ATTACHMENT J

Comments from Other Stakeholders

- ACCCE Comments on BenMAP study
- Comments on Draft MANE-VU Reasonable Progress Goals Document - Dominion
- Comments on Draft MANE-VU Reasonable Progress Goals Document - MOG
- Comments on Draft MANE-VU Reasonable Progress Goals Document - UARG
- Reliant Energy Comments on MANE-VU report
- Modeling for Reasonable Progress Draft Report Stakeholder Comments
- UARG Comments on MANE-VU 2018 Modeling

Figure 1 Composition Plot of Regional Haze at Lye Brook Wilderness Area, 2005

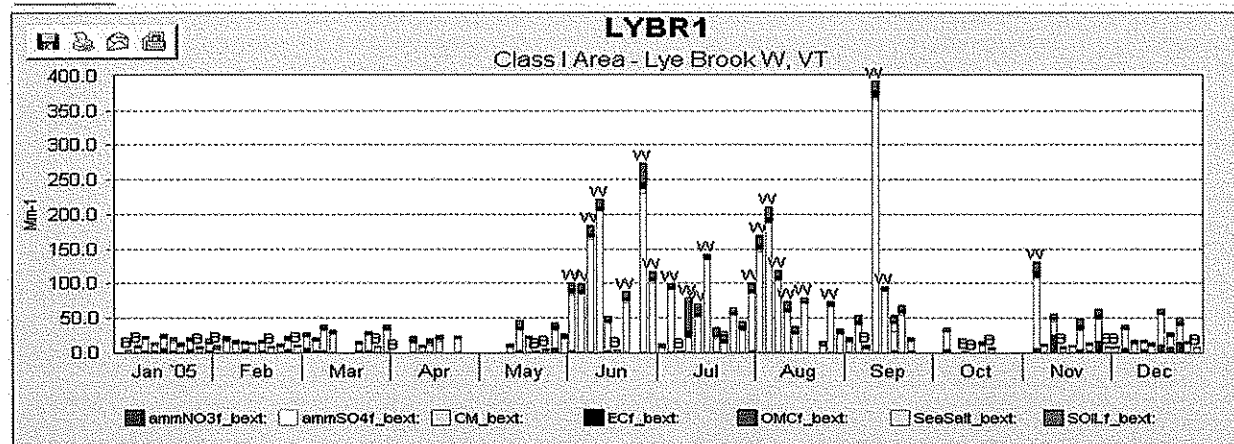
Comment #1 on Section 2: Poor modeled meteorological performance during the summer period has significant implications for conclusions regarding source attribution for regional haze impacts.

The meteorological evaluation indicates that the MM5 performance is poorest during summer conditions (June-August), which is a period that corresponds to many of the worst-case regional haze days (as noted from a review of the IMPROVE data from the web site at <http://vista.cira.colostate.edu/views/>). Therefore, attribution of targeted emission sources that may contribute to the worst 20% days (many of which occur in summer; for example, see Figure 1) is uncertain due to the poor modeled meteorological performance (particularly with regards to the trajectory analysis). It should also be noted that the modeled meteorological performance was poorest for the southern U.S. and interior portions of the U.S. East Coast (NESCAUM states) as compared with other areas included in the model domain. This may have consequences for the accuracy of the efficacy of the BOTW regulations that are advocated by the NESCAUM report.

Figure 2 PM_{2.5} Sulfate Performance Plot from Draft MANE-VU Report

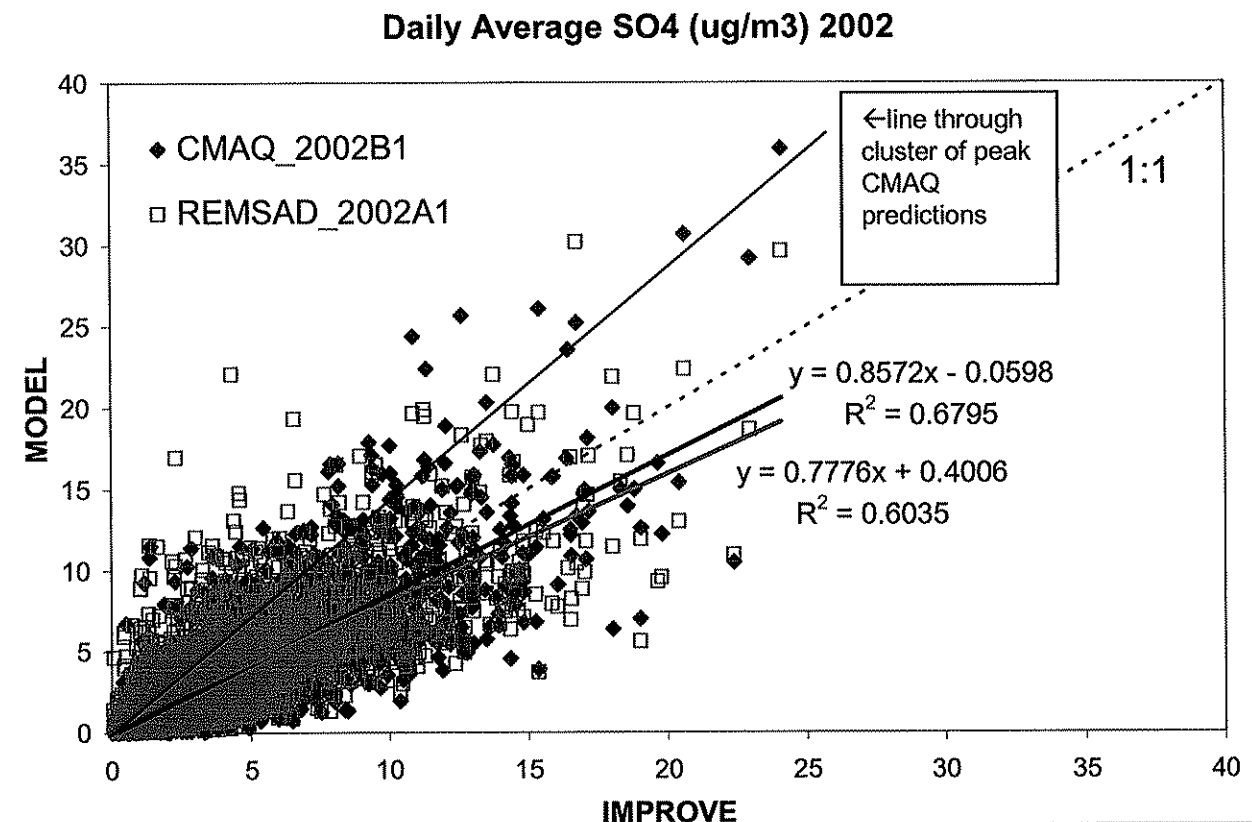
Comment #3 on Section 2: The regression lines and slopes attributed to the model performance plots do not match the peak prediction areas in some cases.

Some of the figures presented in the report (components of Figure 2-11 and Figure 2-16) have best fit lines drawn in the figures that do not appear to match the line one would eyeball that would pass through the peak values. Since the peak values are most important in determining the trend of the worst 20% regional haze days, it makes sense to reconsider the best-fit lines for this purpose. For example, Figure 2 shows the sulfate particulate predictions vs. observations from the report’s Figure 2-11. The blue best fit line far from the area of peak predictions, which are better matched by an alternative line added to Figure 2.

Figure 3 PM_{2.5} Elemental Carbon Performance Plot from Draft MANE-VU Report

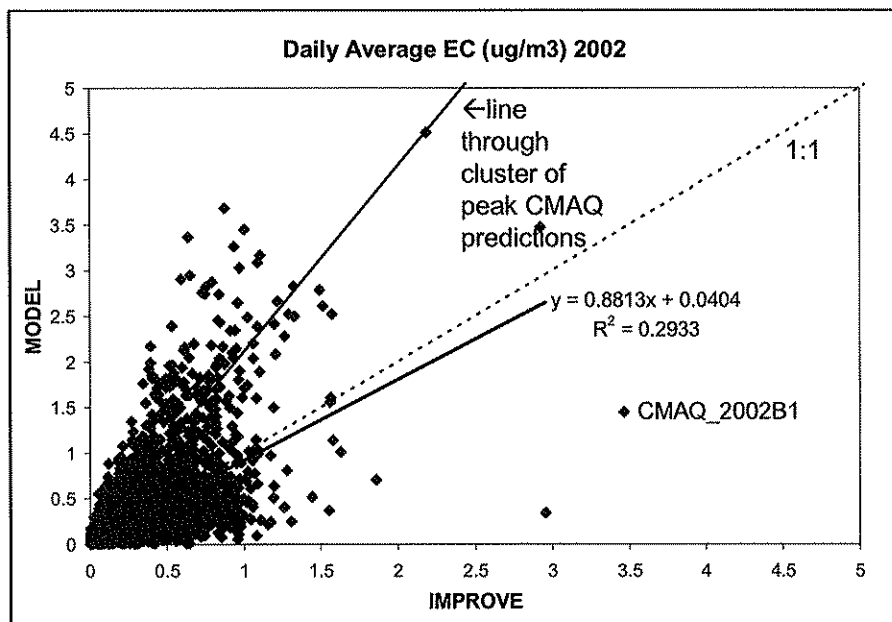
Similar eyeballed best-fit lines through the peak CMAQ predictions are added to Figures 3 and 4. These alternative slopes lead to conclusions that the CMAQ model's peak predictions are too high (i.e., the model is over-responding, especially on the worst 20% regional haze days), and can result in a conclusion that certain emission components have an exaggerated effect on visibility.
